Re: Site Specific Investigation  
Turner Tract Block 2 Lot 4  
Technical Review

This letter serves to present the findings of our technical review of the site specific investigation prepared by Trihydro Corporation (Trihydro) for the City of Laramie for the City owned Turner Tract Block 2 Lot 4 parcel of land located within the Casper Aquifer Protection Area. Our review comments will be presented to address the adequacy of this site specific investigation in fulfilling the requirements of the City of Laramie's Unified Development Code, subsection 15.08.040.A.8.

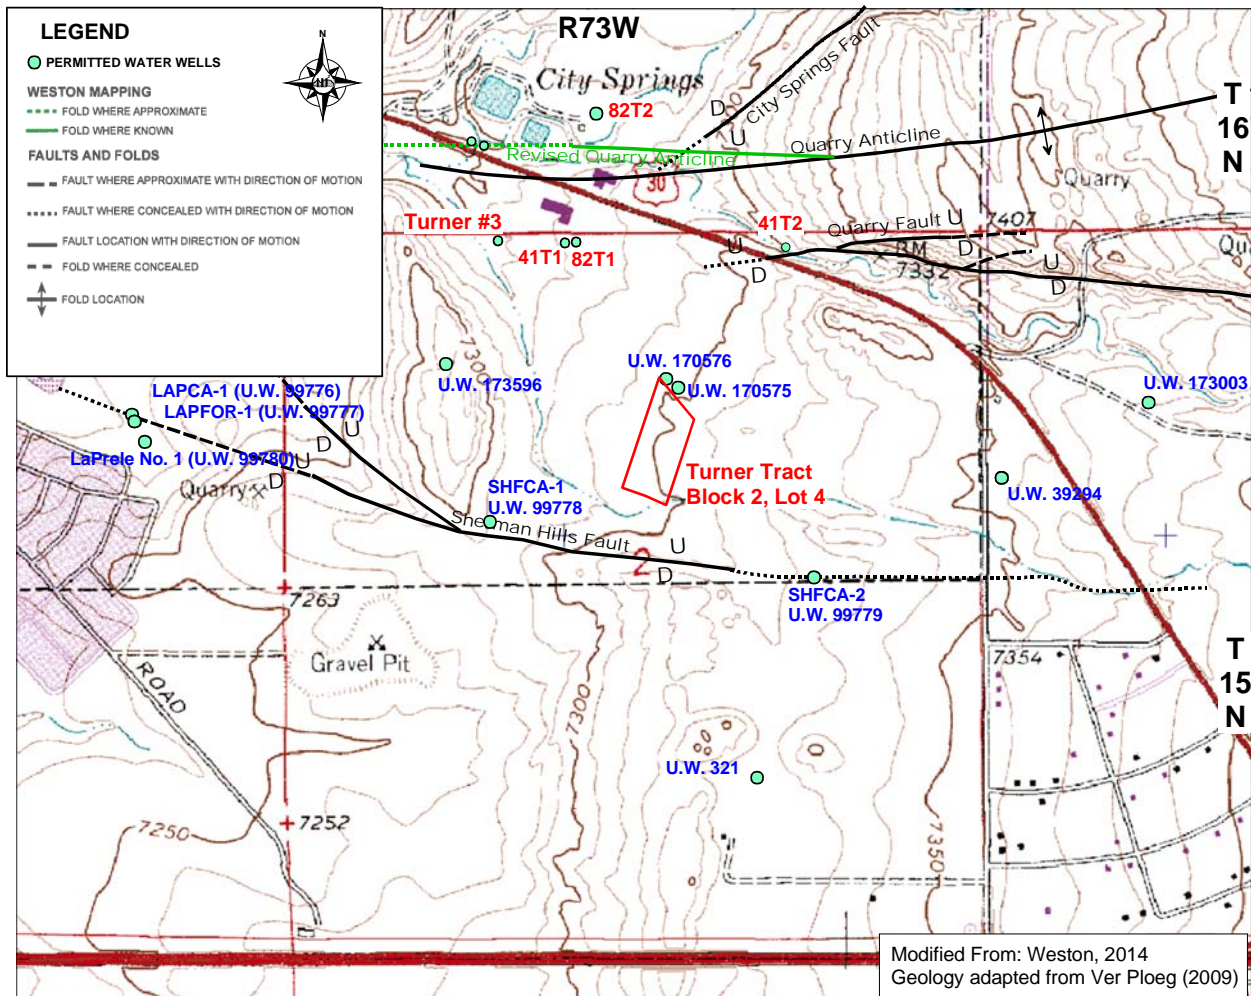
One item that was researched and discussed in later sections of Trihydro's SSI, but not listed in this section of their report, were the State Engineer's Office completion records for the wells in the subject property area. A review of the statement of completion records for the wells in the area indicated that none of the wells in the near vicinity of the Turner Tract Block 2, Lot 4 property were identified as encountering fractures. Five wells in the general vicinity of the subject property referenced either encountering fractures or losing circulation of the drilling fluid during the drilling phase. These wells are the two Wyoming State Highway Department wells (Spring Creek Well Nos. 1 and 2) located approximately ½ mile north of the Turner Tract parcel,

the Bone and Joint #1 Well (U.W. 39294) located approximately ½ mile east of the subject property, the LaPrele No. 1 Well (U.W. 99780) and the LAPFOR-1 Well (U.W. 99777), both located approximately ¾ of a mile west of the Turner Tract parcel. The driller of the Spring Creek wells documented encountering “fractured zones” at depths below approximately 20 feet. The driller of the Bone and Joint well indicated that circulation was lost during drilling from 36 feet below ground level to the well’s total depth at 140 feet and the driller’s log for the LAPFOR-1 and LaPrele No. 1 Wells indicated that fractures were encountered in the Forelle Limestone. The driller’s report for the SHFCA-1 well did not reference any fracturing in this well even though it is very close to Sherman Hills Fault. Although fracturing has been documented in the general area, the lack of fractures in the SHFCA-1 Well and the two Laramie County Community College wells (U.W. 170575 and 170576) indicates that fracturing may not be present at the Turner Tract Block 2 Lot 4 location. The locations of the area wells are shown in the figure below.
